ARCHITECT'S SUPPLEMENTAL INSTRUCTIONS

PROJECT:	The Residence at Green Meadow New Senior Development San Angelo, TX	Report No.	Seven (7)
OWNER:	Overland Property Group Dan Maximuk 234 N. Santa Fe Ave, Suite A Salina, KS 67401	Date	July 9, 2025
CONTRACTOR:	MCP Group 3501 SW Fairlawn Rd. Topeka, KS 66614	Architect's Proj No.	24-3395
		Contract For:	General Construction Mechanical, Electrical

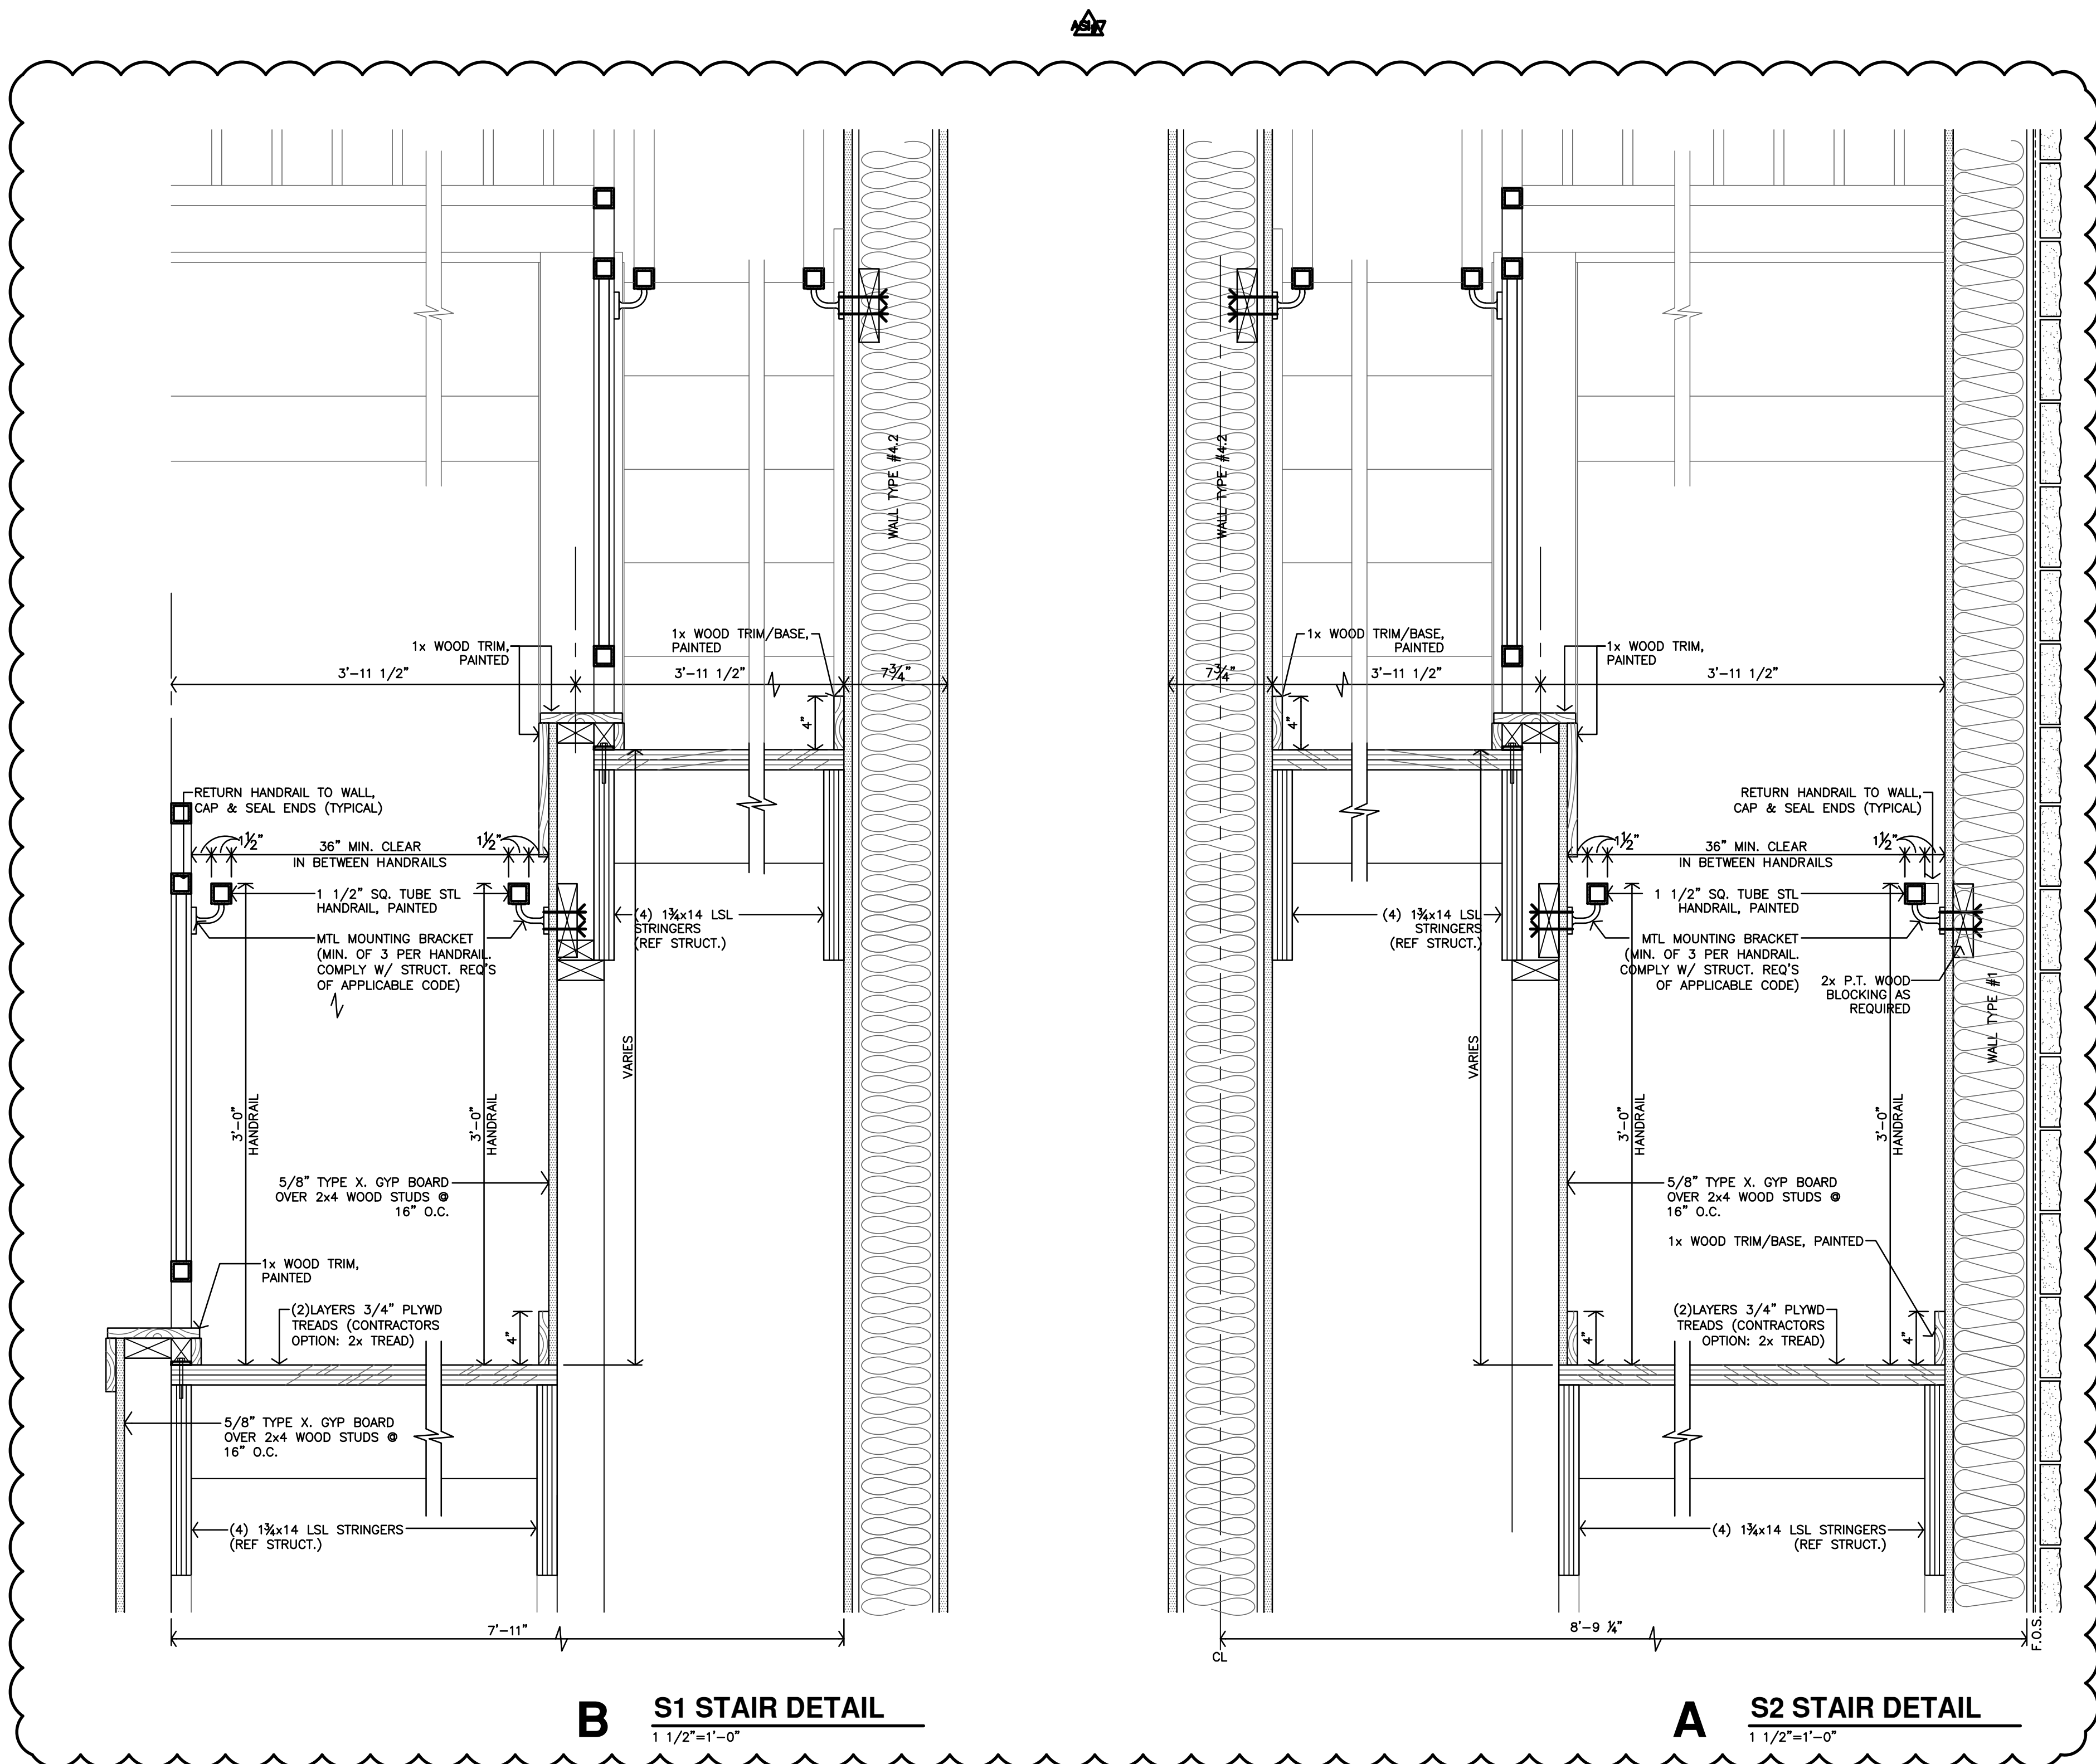
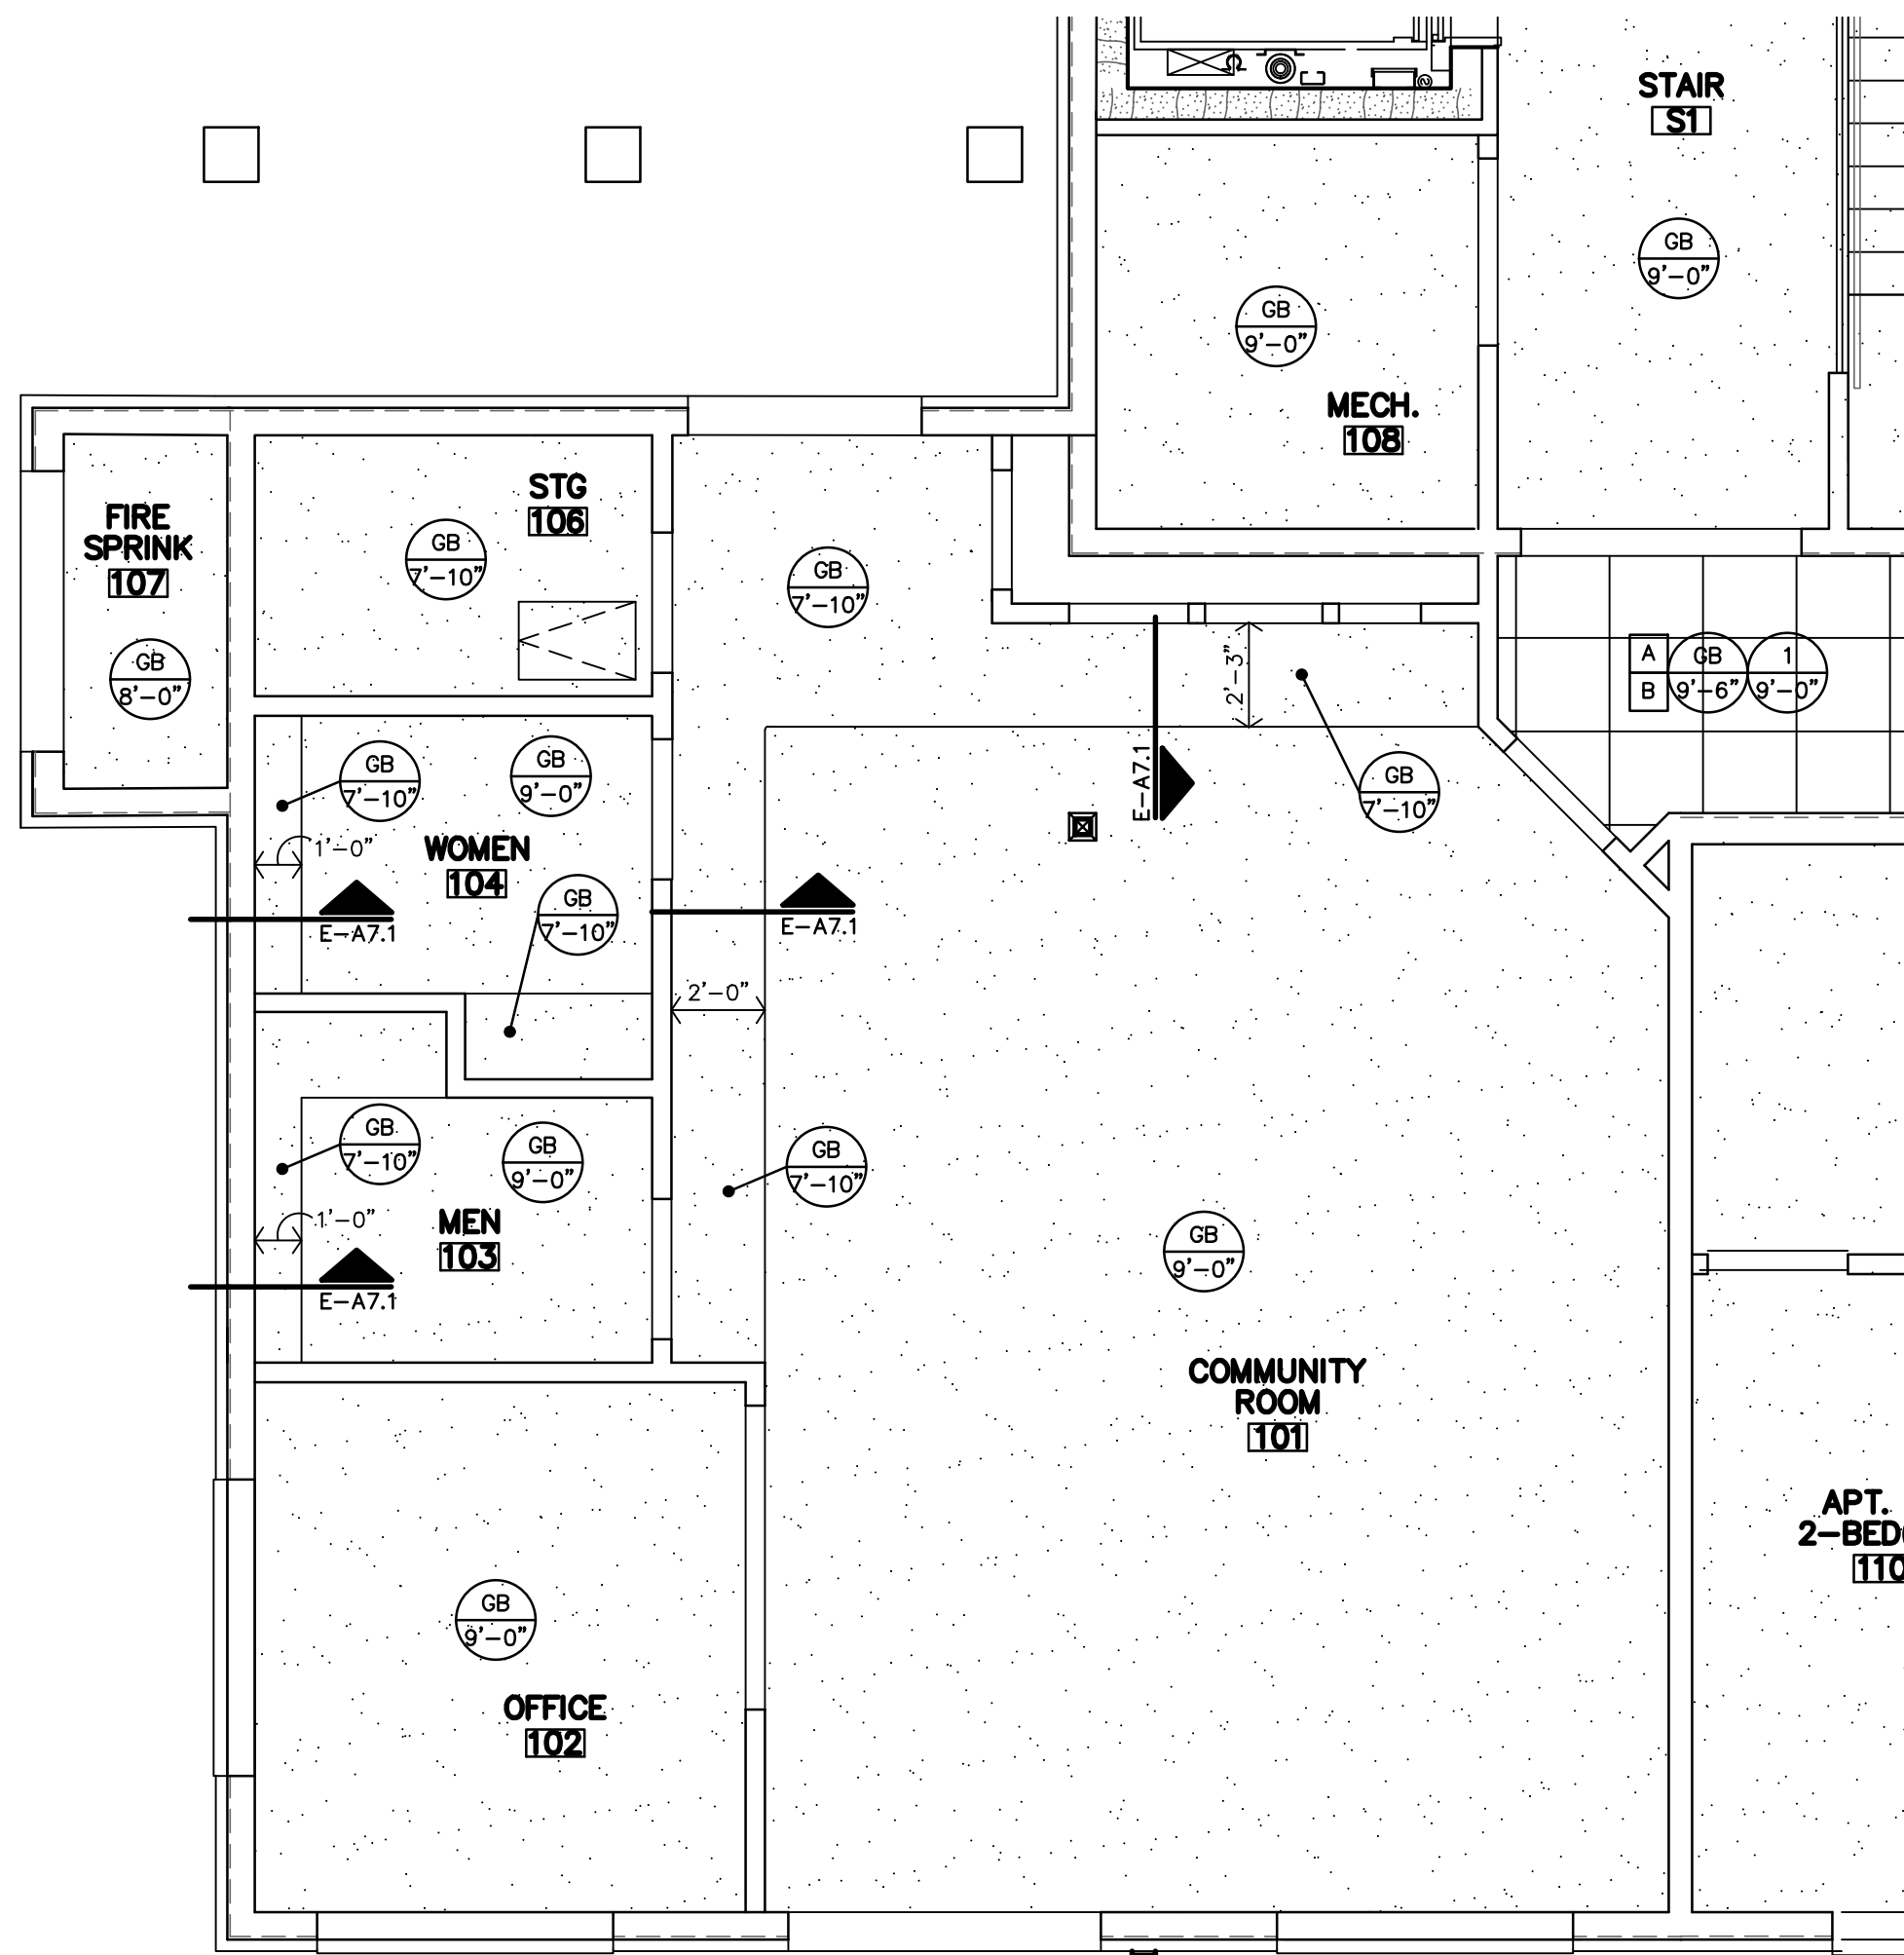
1. Ceilings at S1 and S2, shall be gyp. board over resilient channels, attached directly to joists above. Ceiling will be approx. 9'-6" a.f.f on floors 1 & 2, and approx. 9'-0" a.f.f on floor 3. Reference revised Sheets A7.1 and A7.2.
2. Stair S1
 - a. Detail D-A6.2 has been added to show the finish treatment around the steel beams.
 - b. Details D, E & F-A6.1 have been modified to show the location of the steel column. Extend the wing wall out around the column. The wall should be thickened to a 2x6 wall in lieu of a 2x4 wall.
3. Stairs S1 & S2
 - a. Sheet A6.3 and Details A & B-A6.3 have been added to show the finish underneath the stringers at the first floor.
